N5245A-04A

S E R V I C E N O T E

N5245A PNA Series Microwave Network Analyzers

Some analyzers are exhibiting unlocked or unleveled errors or other unexpected digital control faults. Analyzers that experience any of the symptoms listed on page 2 of this document must be inspected for a possible return to Agilent to have the system motherboard replaced.

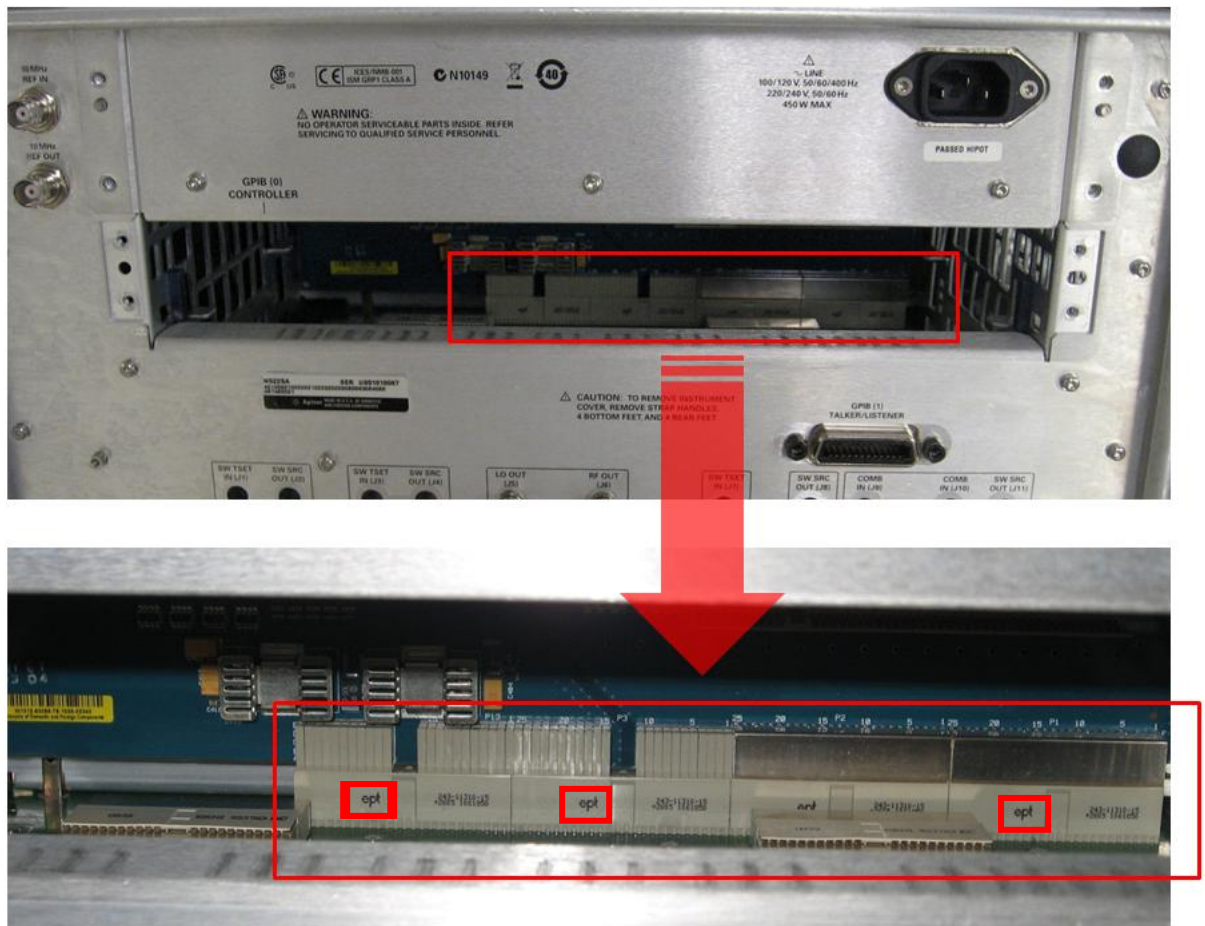
1. Remove the CPU assembly from the analyzer's rear panel. Refer to the PNA Service Guide chapter 7 section titled, "Removing and Replacing the CPU Board Assembly" for removal and reinstallation procedures. To view the online Service Guide, see the numbered list on the next page for instructions.
2. As per the photo below, inspect the system motherboard connector to see if it has one or more "ept" logos.

3. If the connector has one or more “ept” logos, return the analyzer to Agilent for replacement of the system motherboard. If the connector does not have one or more “ept” logos, email ctd-soco_support@agilent.com, providing the analyzer model and serial number and details of the malfunction symptoms.

4. *For Agilent Service Technicians only:* Only new boards without “ept” logos should be installed. Before installing the new board, look to see if it has one or more “ept” logos. If so, email ctd-soco_support@agilent.com, providing the analyzer model and serial number. Wait for further instructions in an email reply. New boards without “ept” logos can be installed. For installation instructions, refer to the PNA Service Guide chapter 7 section titled, “Removing and Replacing the System Motherboard.” To view the online Service Guide, see the numbered list on the next page for instructions.
